Exelon Generation Company, LLC

Braidwood Station, Unit 2
Facility Operating License No. NPF-77
NRC Docket No. STN 50-457

Subject: Response to Request for Additional Information Regarding the Steam Generator Tube Inspection Report for Braidwood Station, Unit 2, Refueling Outage 17

Three-Tube Periphery Array Probe (X-probe) Inspections Tube sheet Maps

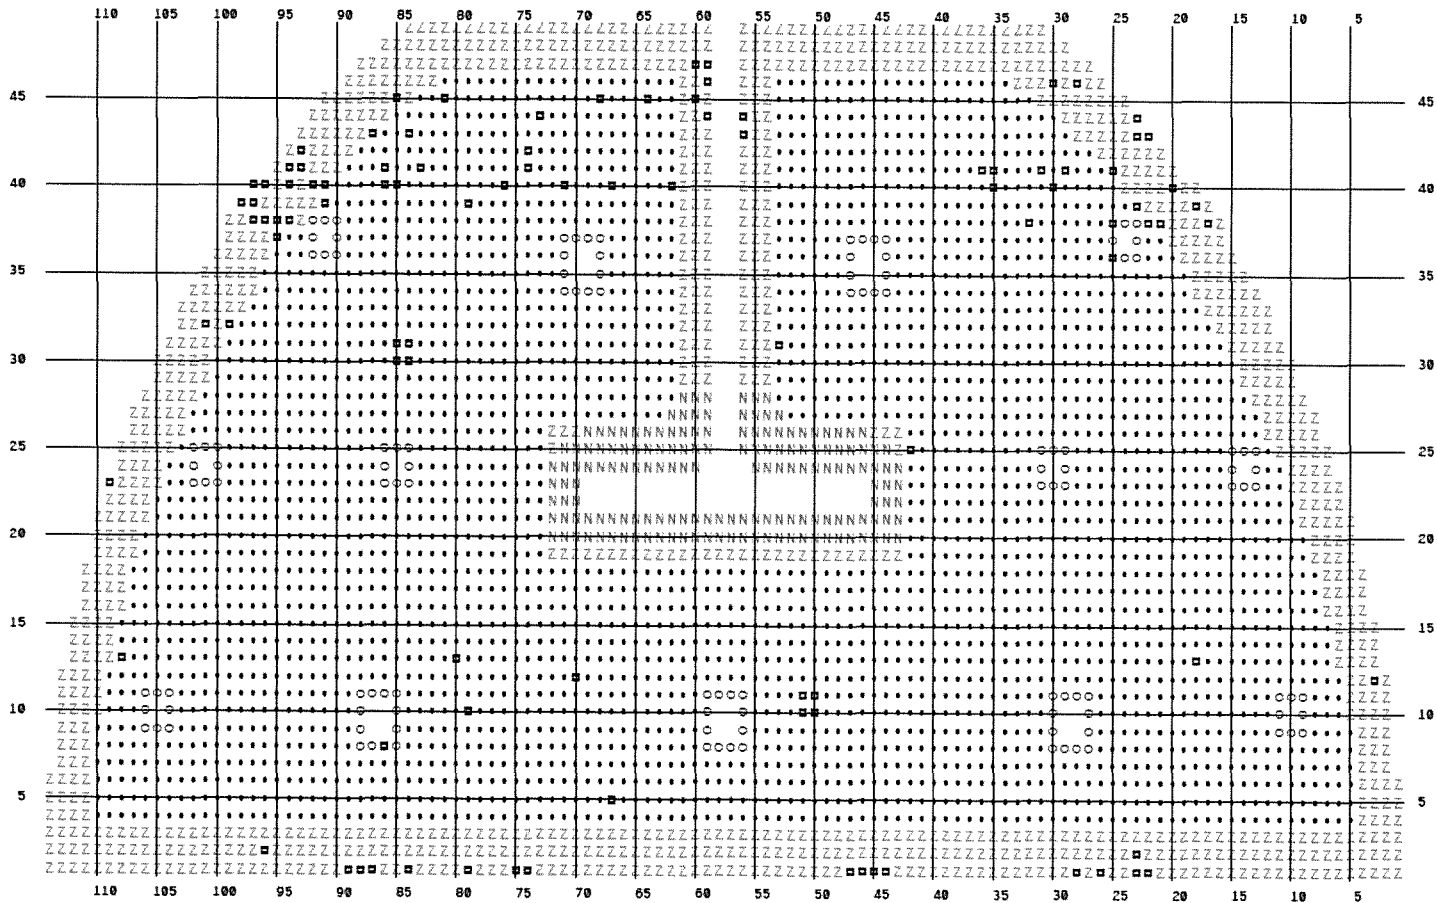
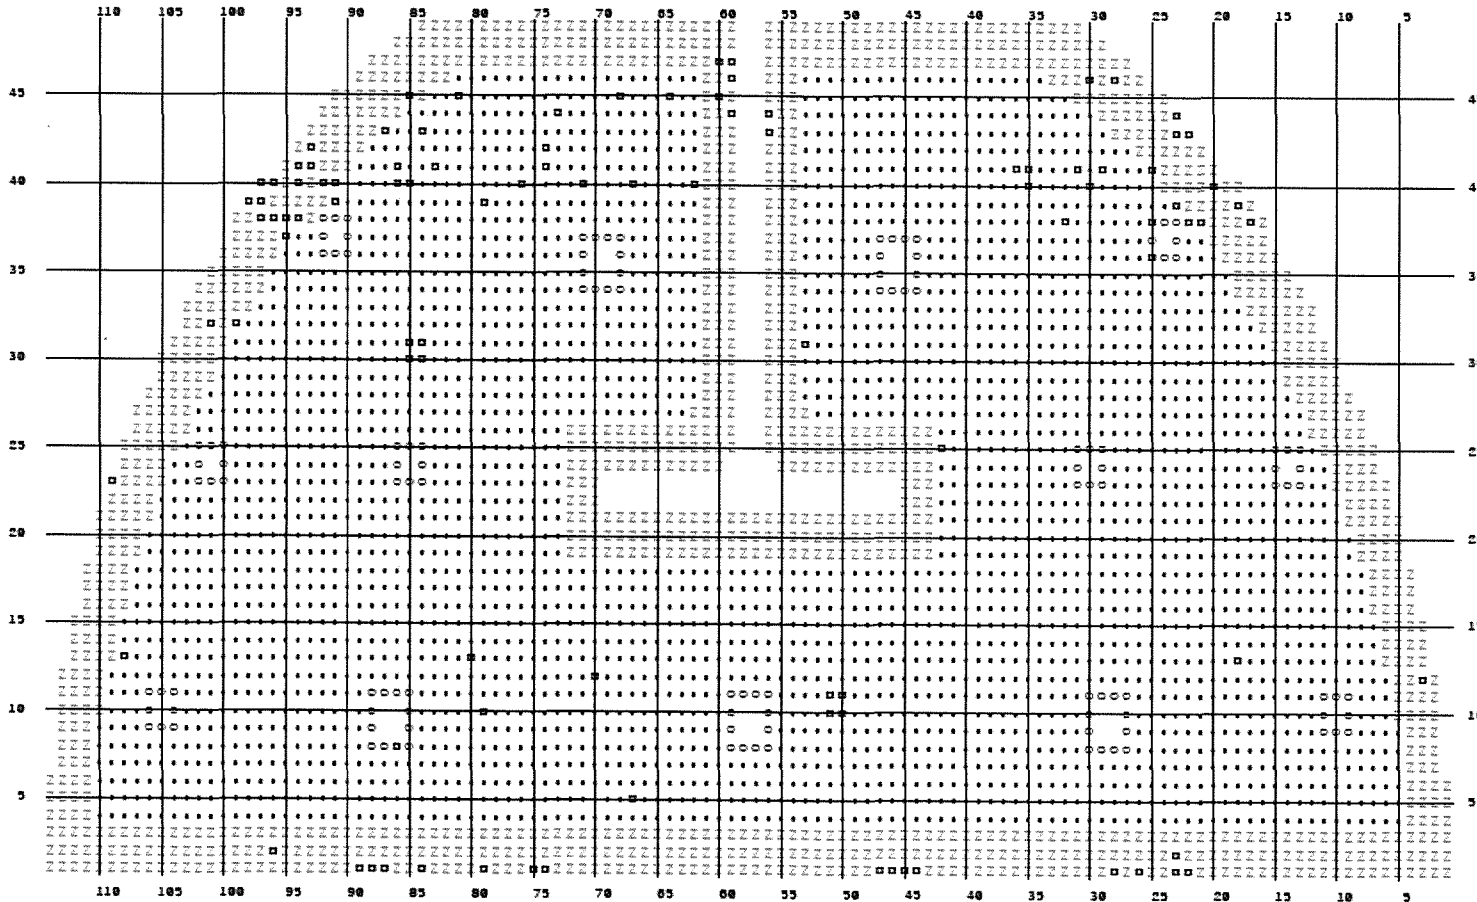
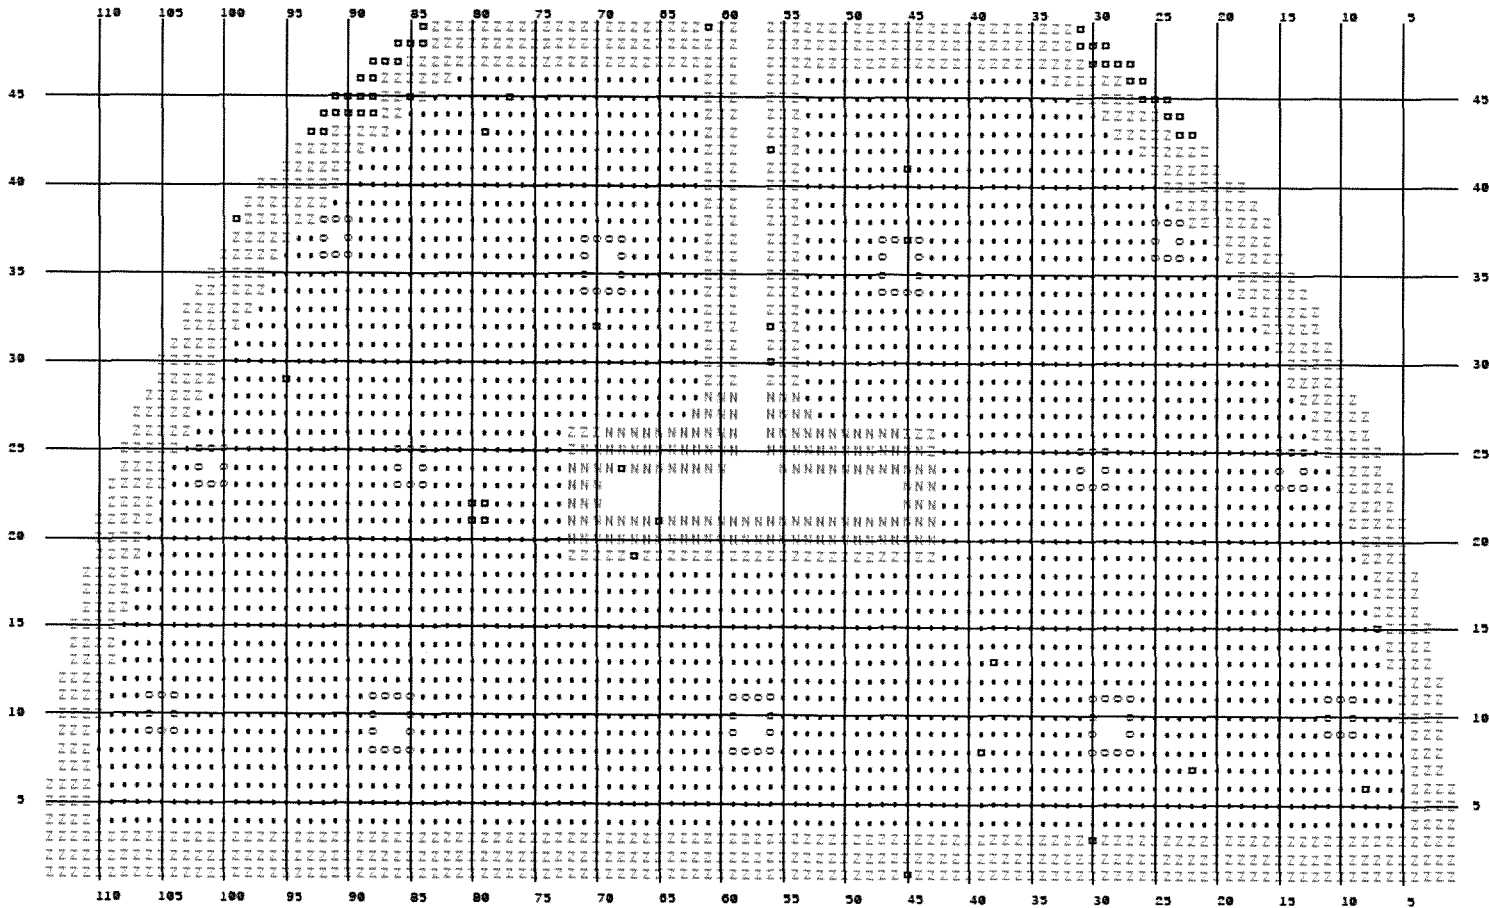
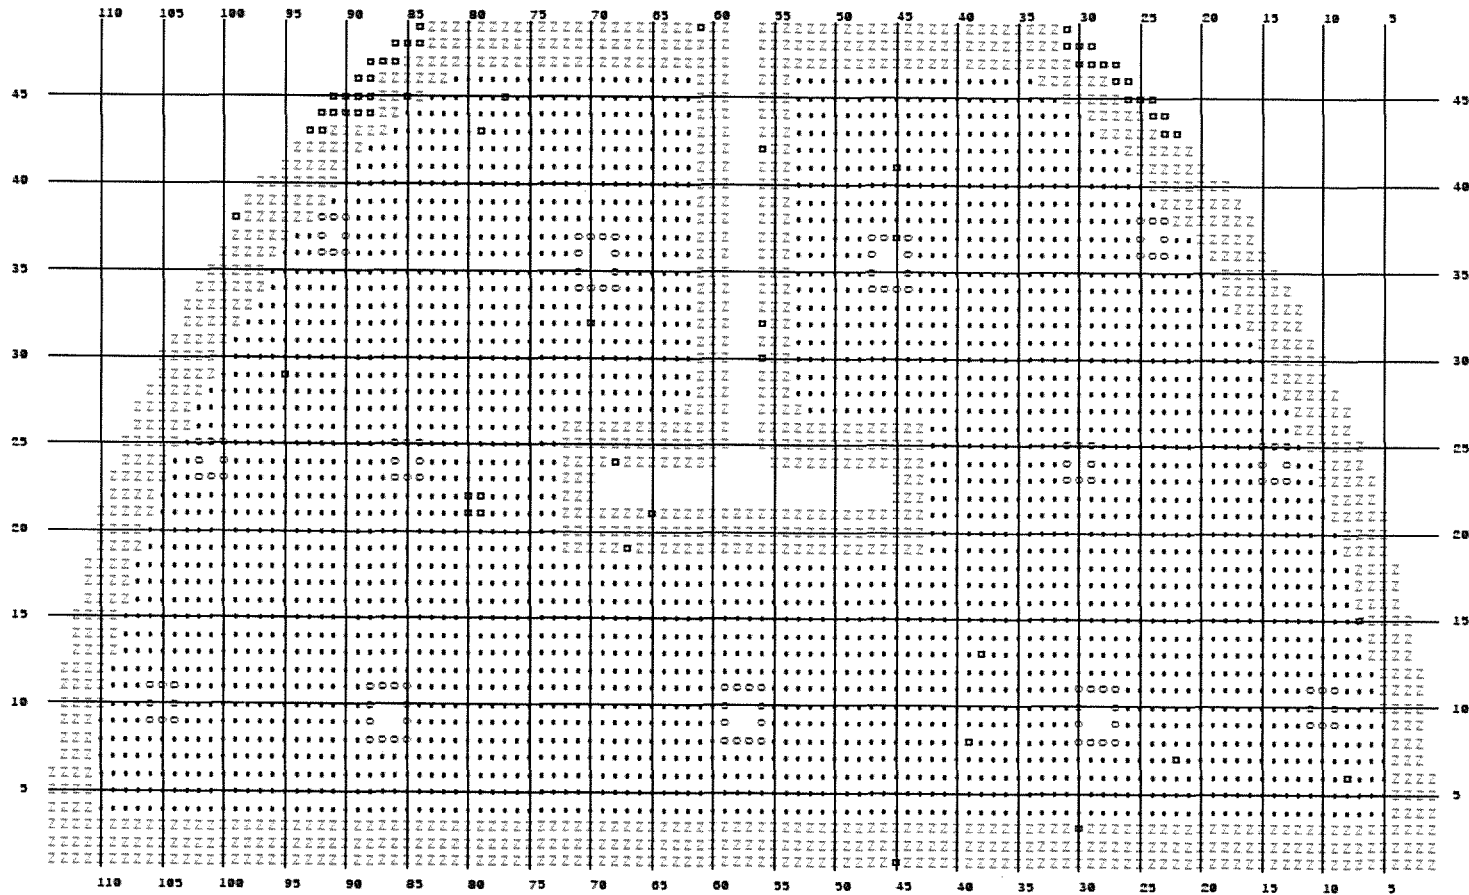
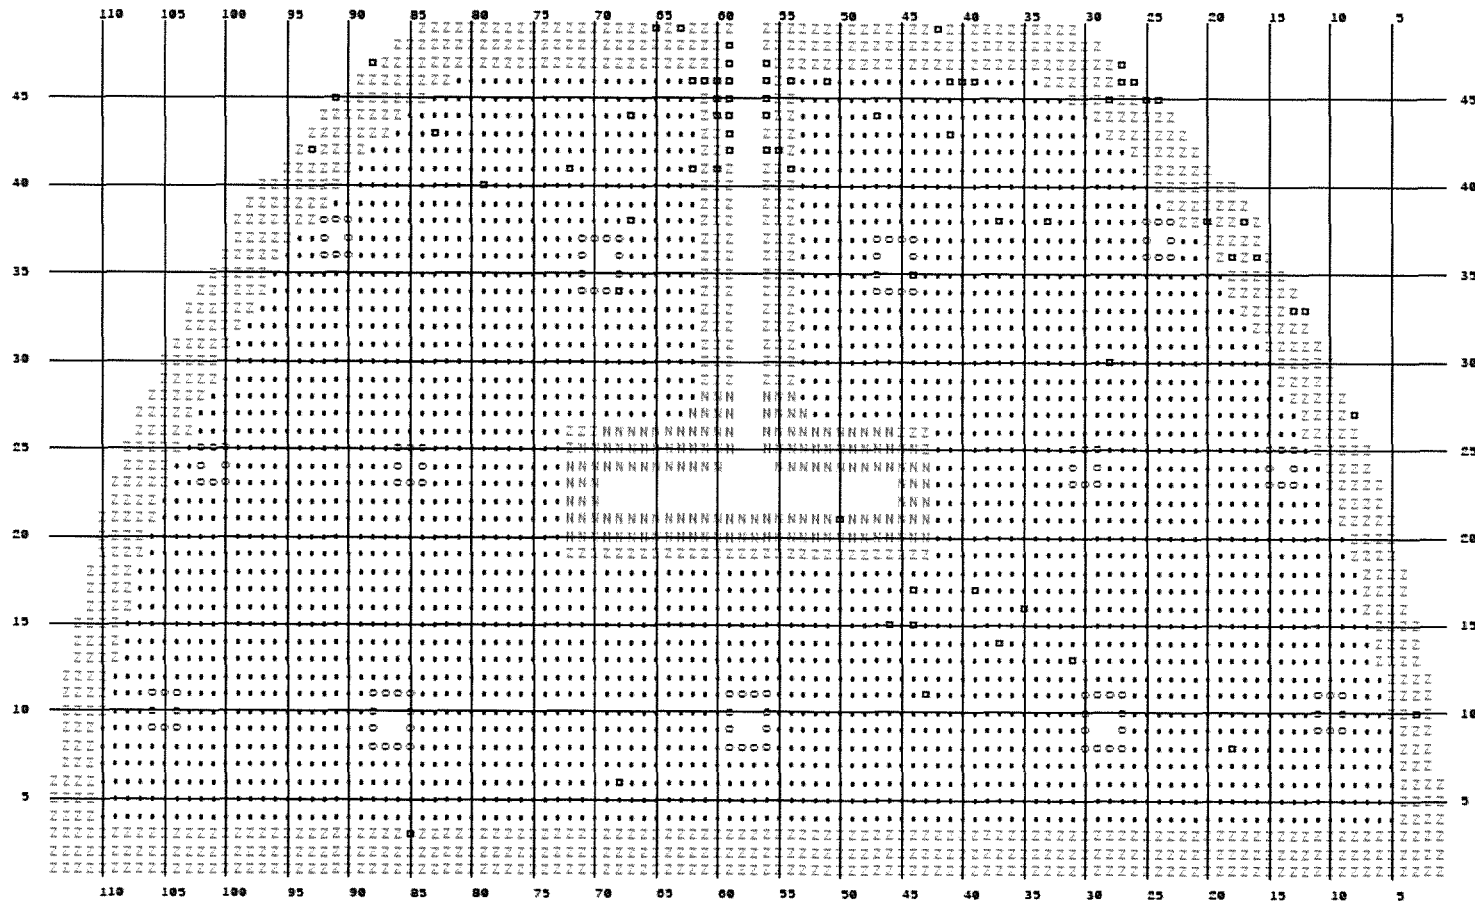
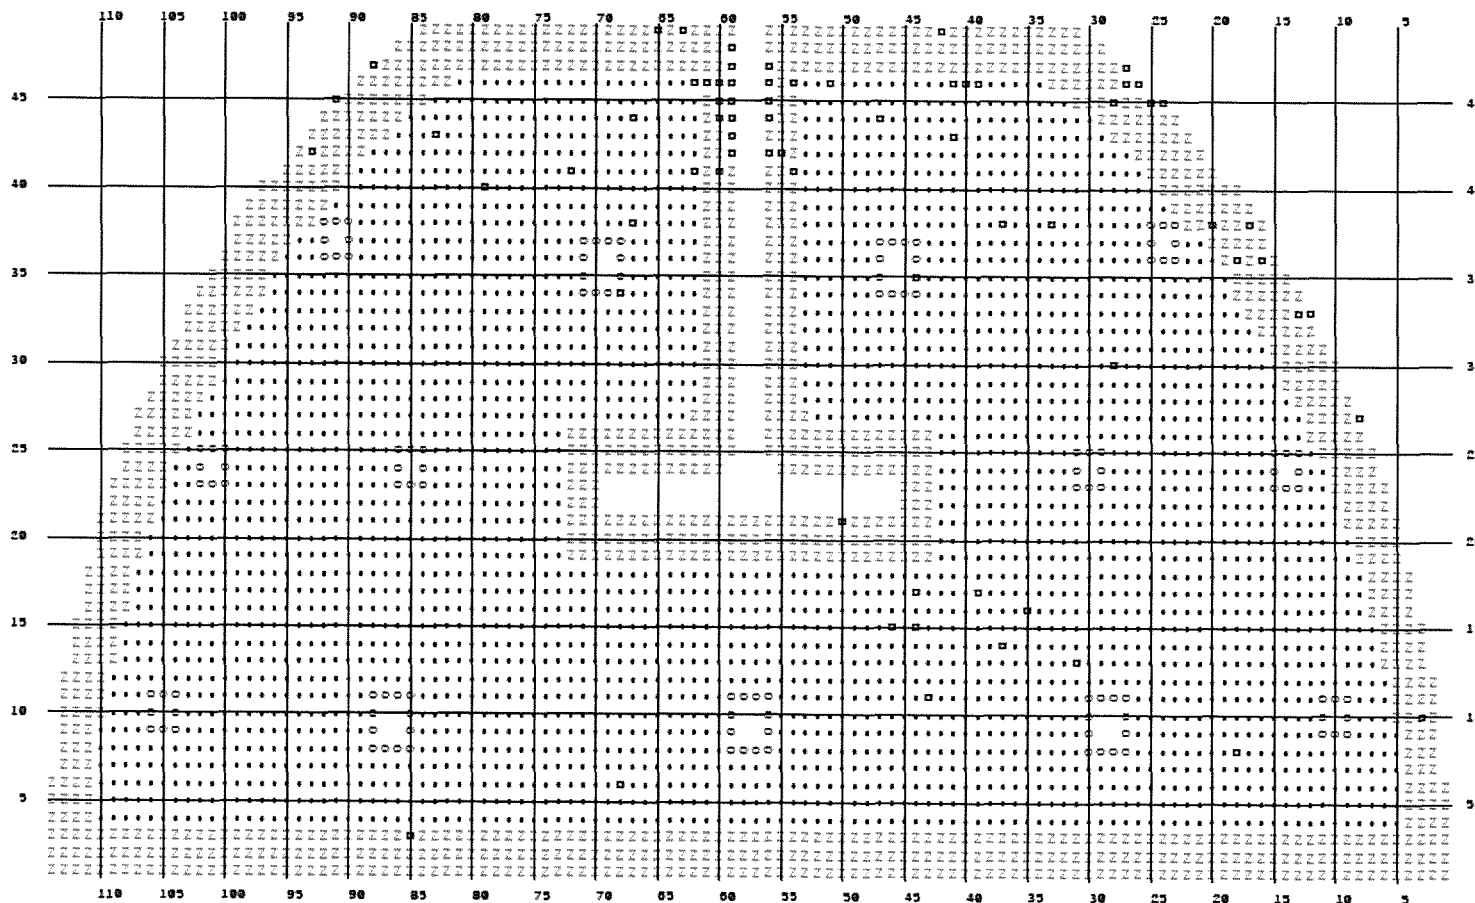
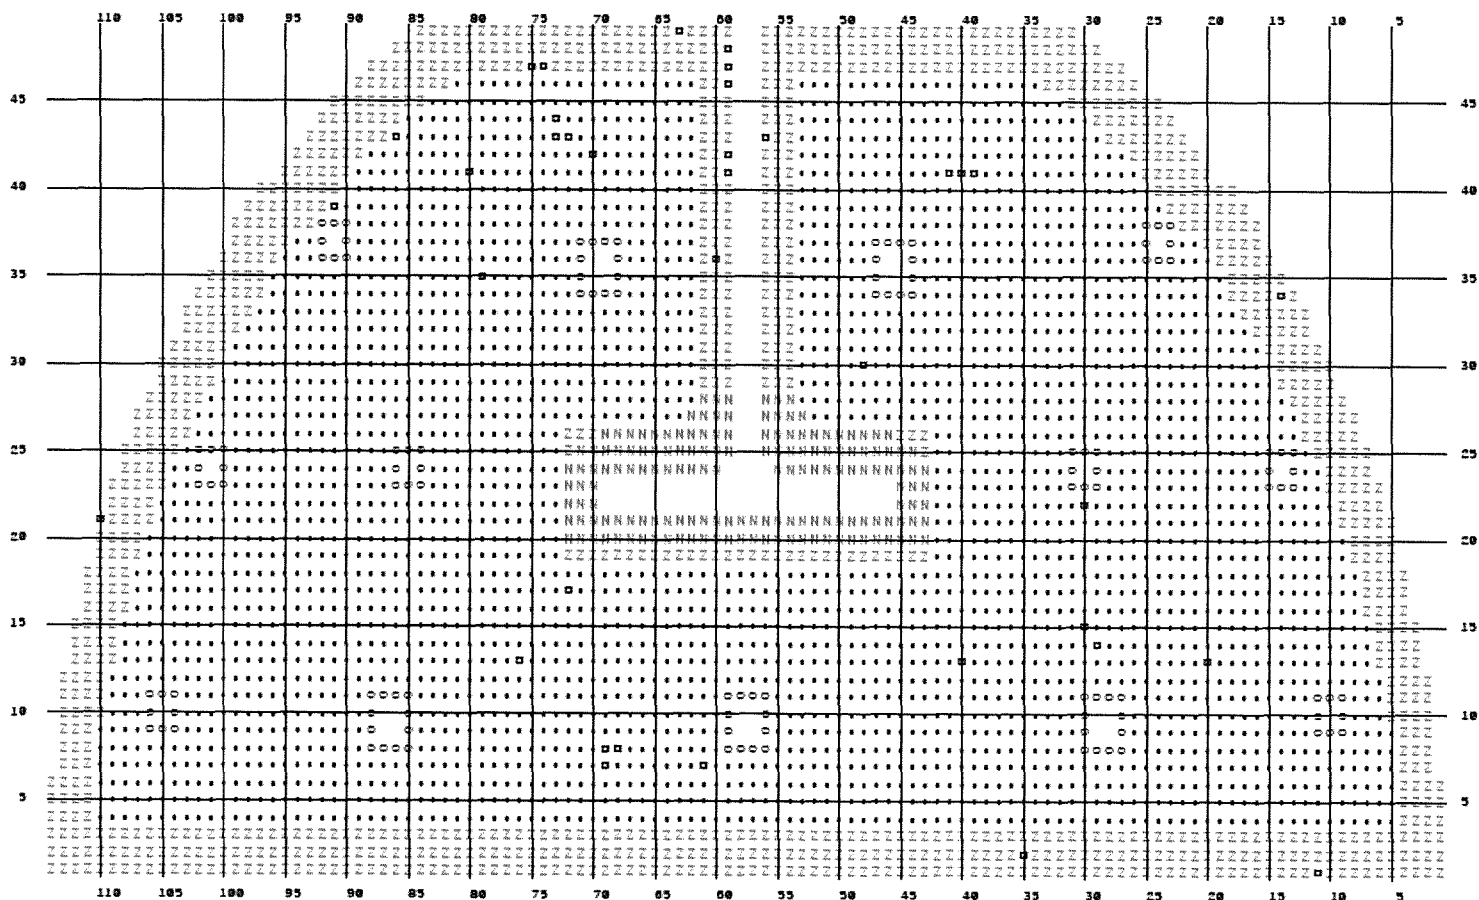
Your November 14, 2014, submittal indicated that three tubes deep around the entire periphery, including the no tube lane and T-slot, were inspected in all four SGs with an X-probe. Clarify the axial extent of these exams (e.g., tube-end to tube-end, H distance to first support on both hot-leg and cold-leg). Discuss whether or not these exams included both hot-leg and cold-leg regions.*

The axial extent was the tube end to flow distribution baffle (1st Tube Support Plate (TSP) -01C or 01H) for the entire periphery scope, including the no tube lane and T-slot. In the "head" of the T-slot on the hot leg, the extent of the exam was extended from 01H to 03H. The exams included both the hot leg and cold leg regions. This is shown in the attached tube sheet maps in Attachment B.
